DETERMINATION OF NON-SIGNIFICANCE

FILE NUMBER: 12-104786-LD

City of Bellevue
Development Services Department
Land Use Staff Report

Proposal Name:	The Madison of Bellevue
Proposal Address:	15420 NE 8th Street and 825 156th Street
Proposal Description:	Application for Design Review approval to construct three multifamily buildings, a fitness center and leasing office at the Madison of Bellevue, formerly known as the Lamplighter Apartments. Modifications to parking and landscaping will occur with this application. The site lies within the Single Family Transition Area Design District.
File Number:	12-104786 LD
Applicant:	The Madison of Bellevue Land, LLC
Decisions Included:	Design Review and SEPA, Process II
Planner:	Antoinette Pratt, Senior Planner
State Environmental Policy Act Threshold Determination:	**Determination of Non-Significance** Carol V. Helland, Land Use Director Development Services Department
Director's Decision:	**Approval with Conditions** Michael A. Brennan, Director Development Services Department Carol V. Helland, Land Use Director

View of Pool Building

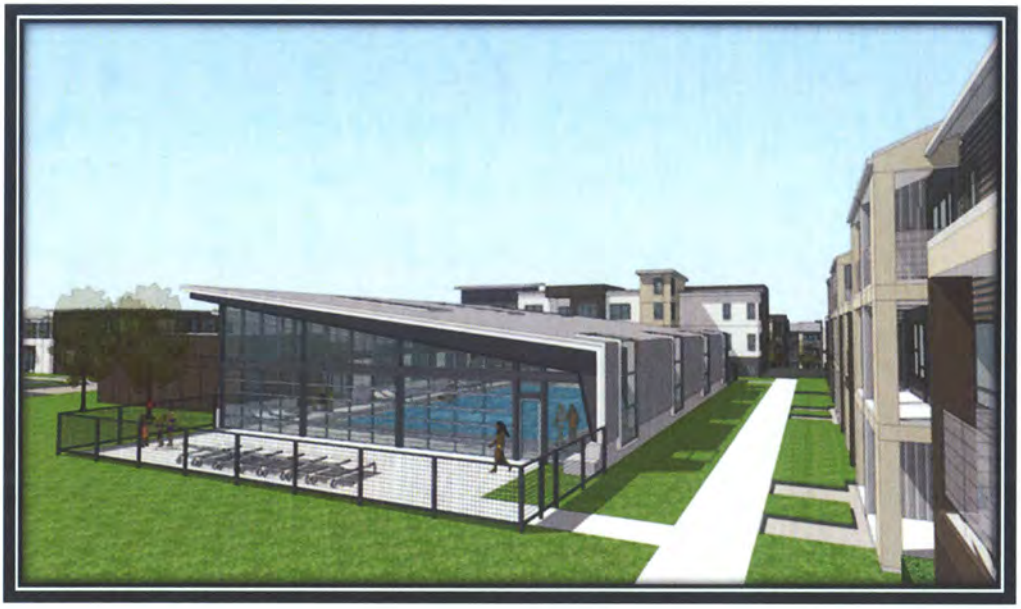
- The applicant will be removing two existing pools with this application. A new pool will be constructed north of the fitness building. At the time of submittal, this pool was uncovered. During review of this proposal, weather protection was suggested for outdoor amenities. An enclosure was added to cover the pool to allow resident usage at all times of the year. See below:

(Figure 3: Transportation Mitigation Measures)

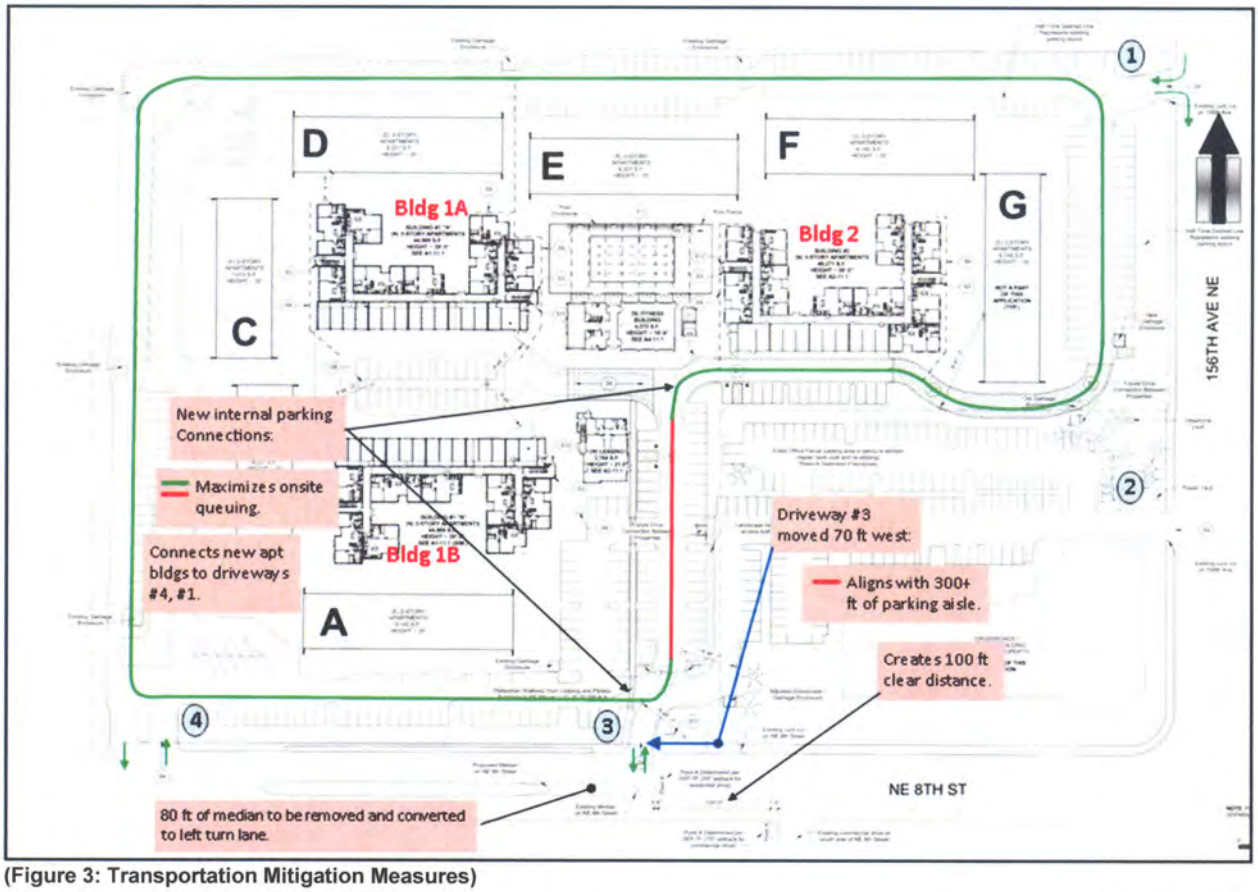
iii. New internal connections between the parking areas of the Madison Apartments complex and the DSHS building will maximize on site queuing and connect the new apartment buildings to driveways #1 and #4.

k. Construction of on-site connections between the DHSH building and the Madison Apartments parking areas as shown in figure 3. This work will include removal of existing landscaping, curbing and paved areas and the creation of new parking aisles as shown in figure 3.
